TECHNICAL MEMORANDUM

TO: DONALD WASHBURN, ENGINEERING
TECHNICIAN
FROM: KEITH STEWART, P.E.
MAYA VITA, E.I.T.
DATE: NOVEMBER 14, 2025
SUBJECT: PINNACLE DEVELOPMENT WATER
SYSTEM ANALYSIS
CITY OF POULSBO, KITSAP COUNTY,
WASHINGTON
G&O #25520.00

CITY OF POULSBOR
PINNACLE DEVELOPMENT
WATER SYSTEM ANALYSIS
FIGURE 2
SYSTEM PRESSURE AS CURRENTLY PROPOSED - 0 PRVs

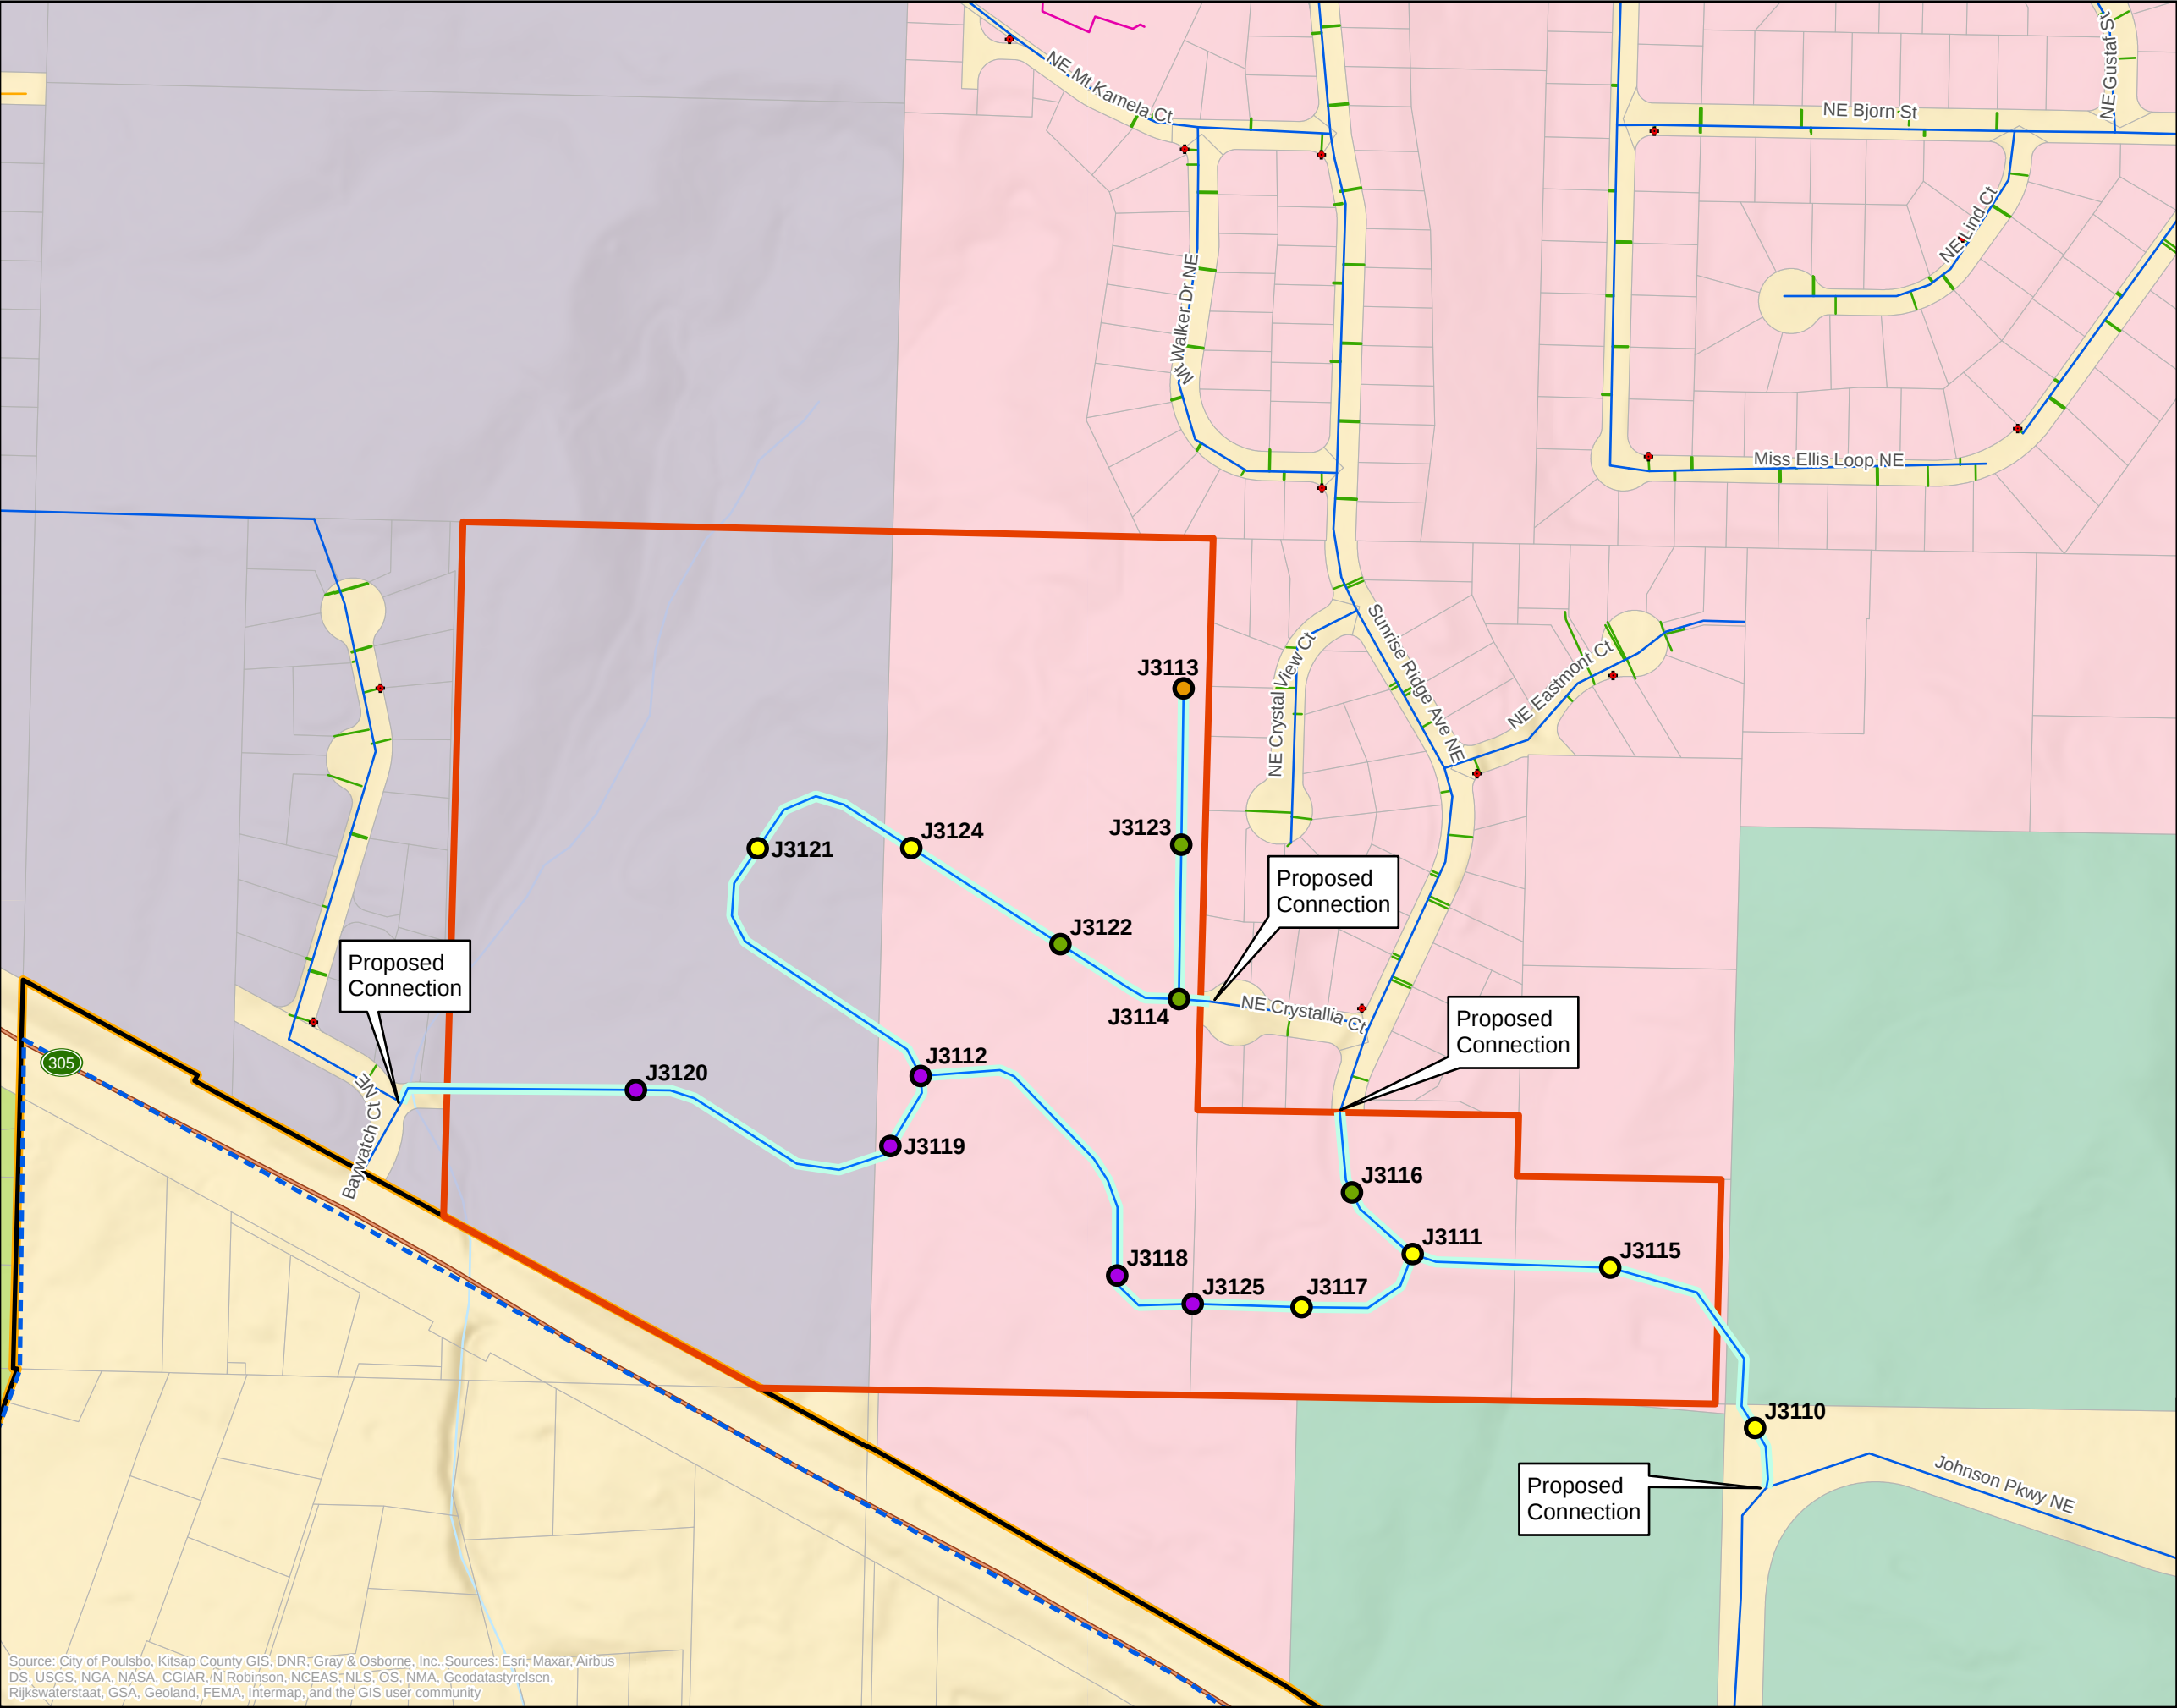
It should be noted that this proposed development is in an extremely difficult location, with a highly variable topography and a location that spans the East High Zone, Middle Zone, and East High Subzone.

For this analysis, the system was modeled under two scenarios. Scenario 1 included the water system infrastructure as proposed by the Developer. This scenario included connections at Baywatch Court Northeast, Sunrise Ridge Avenue Northeast, and Johnson Parkway Northeast, and 8-inch diameter ductile iron water main piping. The output from this scenario is shown in Figure 2.

The model output shows that most nodes fall within the City's desired pressure range of 50 to 80 psi. Note that Nodes J3122 and J3120 show pressures above 80 psi during peak hour flows, and residences in this area may need to be served by individual residential PRVs.

CITY OF POULSBO
PINNACLE DEVELOPMENT
WATER SYSTEM ANALYSIS
FIGURE 3
**SCENARIO 2 SYSTEM PRESSURE
WITH RECOMMENDED IMPROVEMENTS**

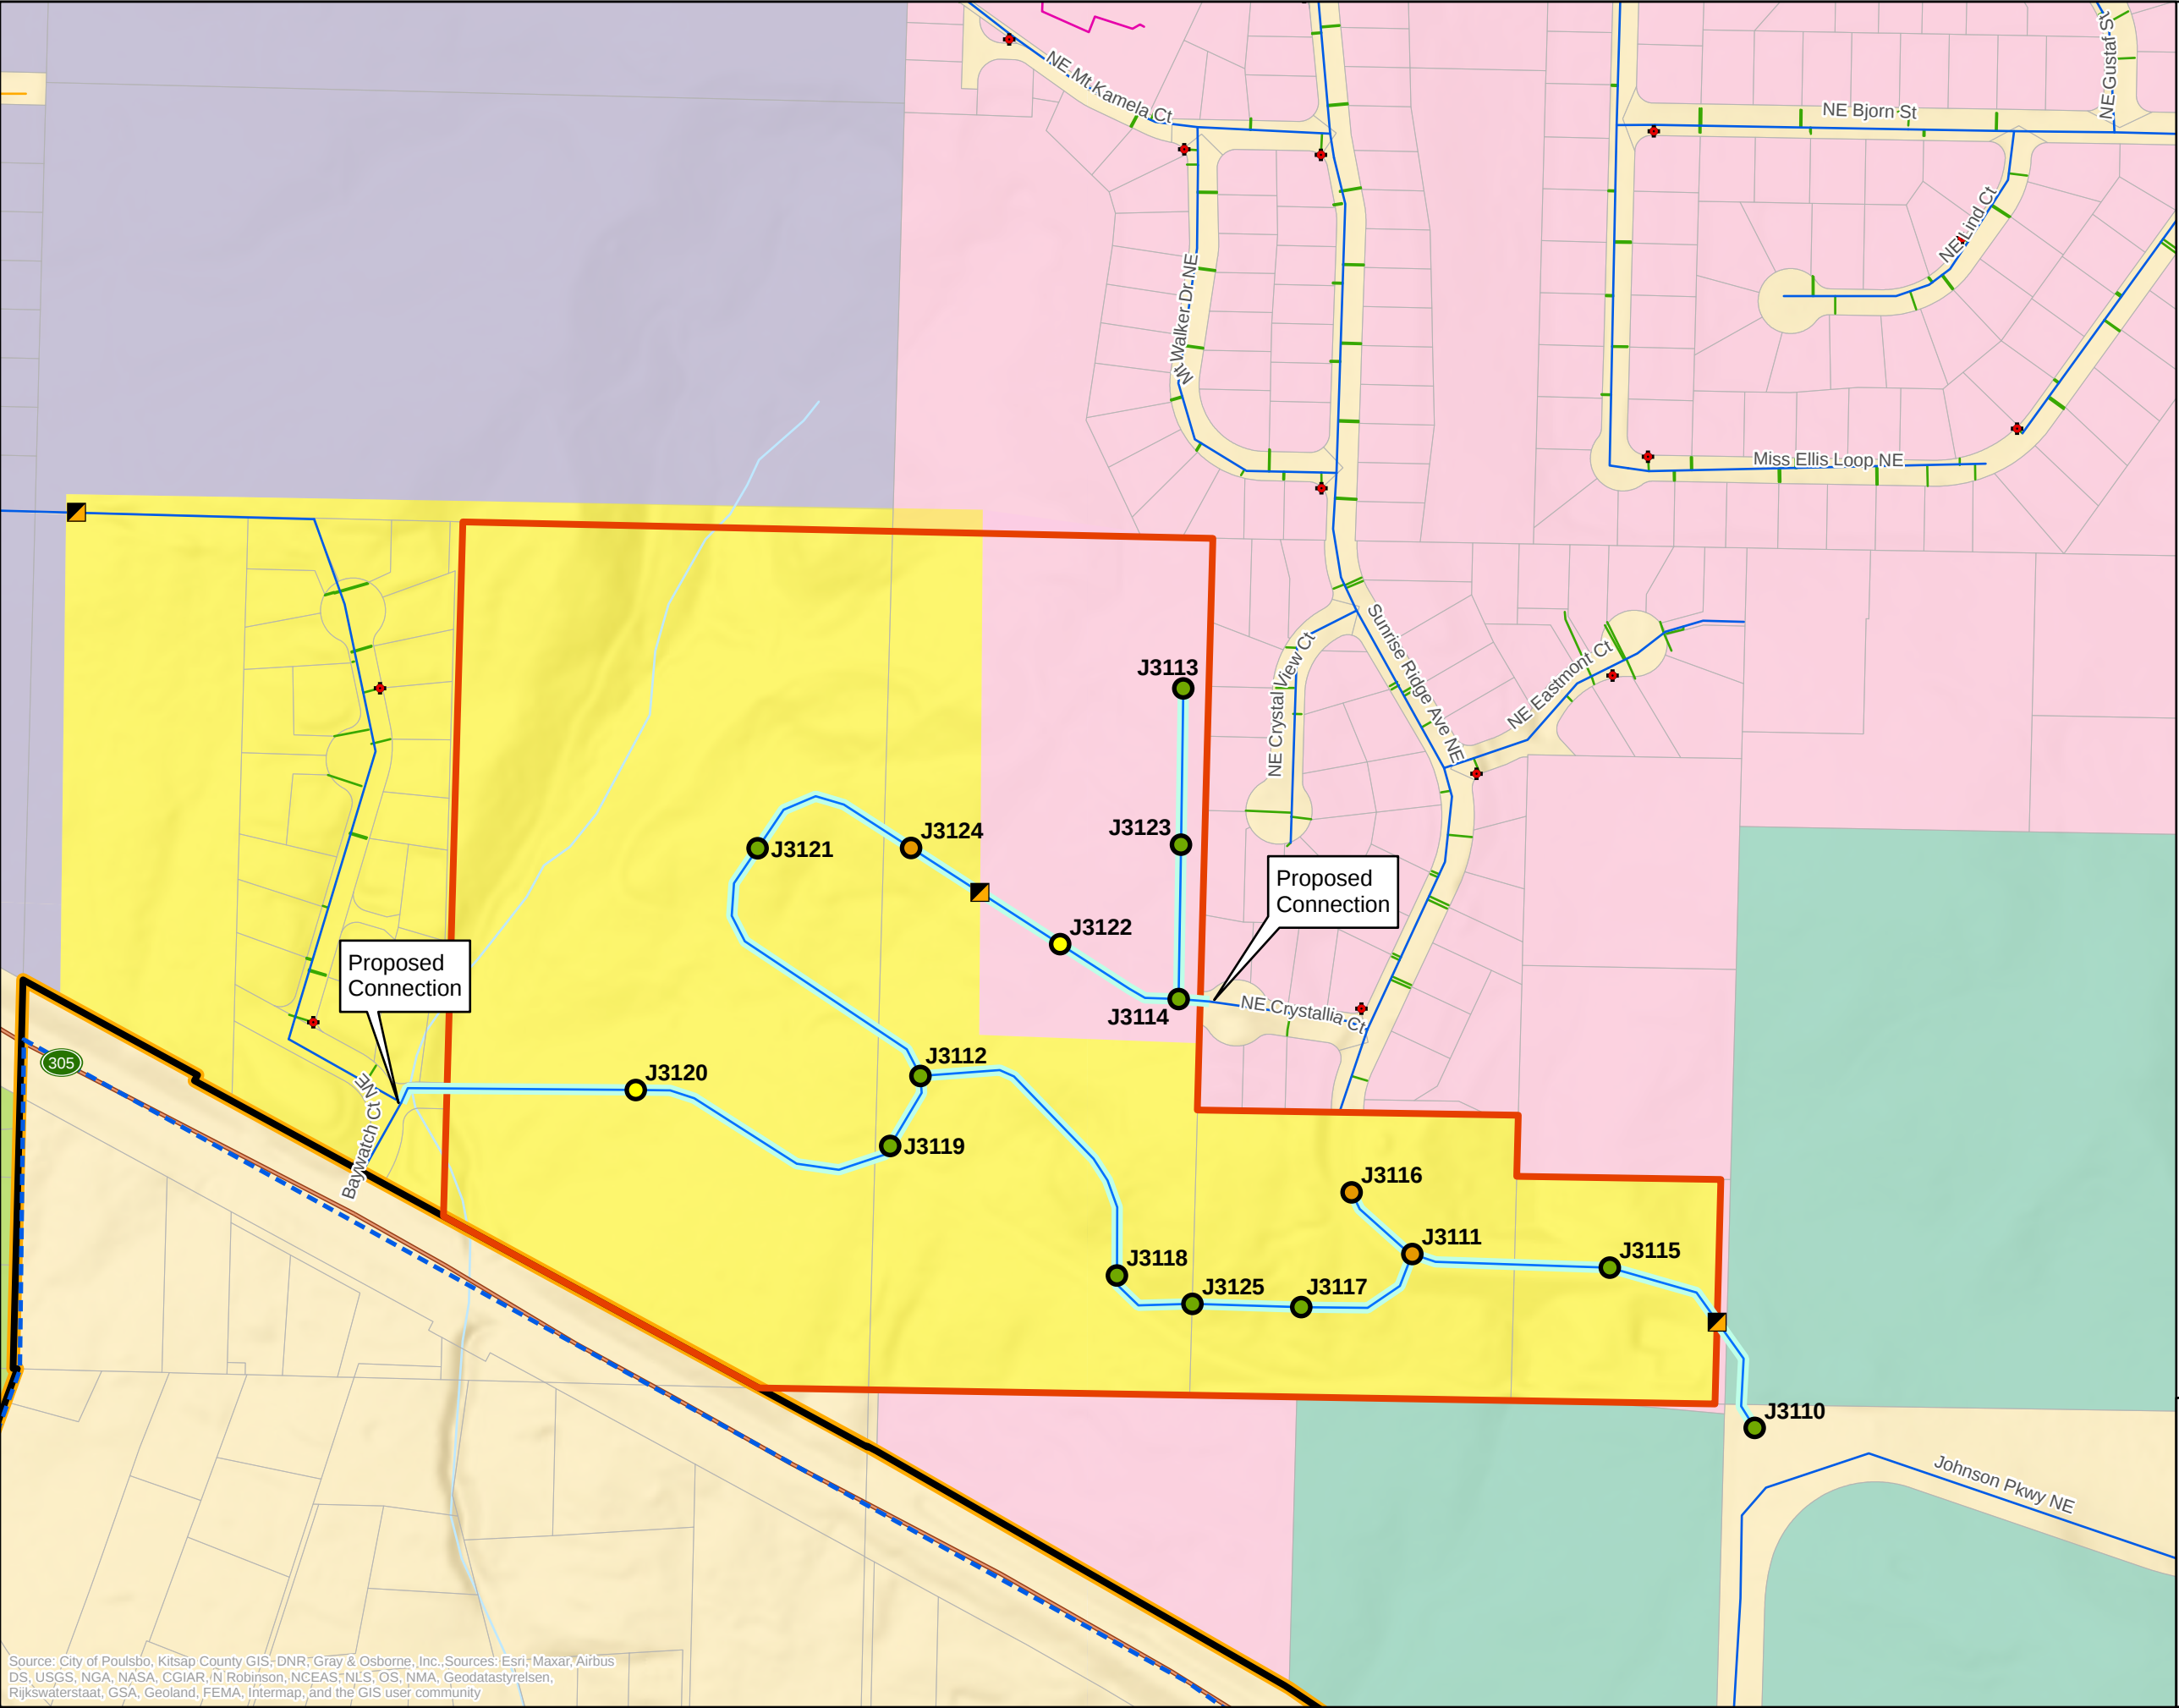
Scenario 2 was the recommended system based on an investigation of proposed building elevations, proposed development in the area, and desires of City staff with regards to pressure, maintenance, and zone delineation. Scenario 2 includes a combination of PRVs, connections to the East High Zone and Middle Zones, creation of a new Middle Subzone, and individual residential PRVs. The PRV station settings for Scenario 2 were modeled as follows to achieve a consistent hydraulic grade line (HGL) of roughly 355 feet for the new subzone.

- Crystallia: 37 psi
- Johnson: 59 psi
- Baywatch (if the City installs a PRV at the existing valve): 57 psi

The modeled PRV locations and output of the model results for Scenario 2 are shown in Figure 3. Model output values are also summarized in Table 1.

The PRV settings would need to be adjusted after installation to optimize flow and operation, in order to maintain a consistent water pressure and regular flow through each station. This optimization should be performed by City staff.

Under this scenario, the City would own, operate, and manage the PRV stations in order to ensure they are maintained and operated in accordance with the needs of the public water system. The cost for construction of these PRV stations would be borne by the Developer.
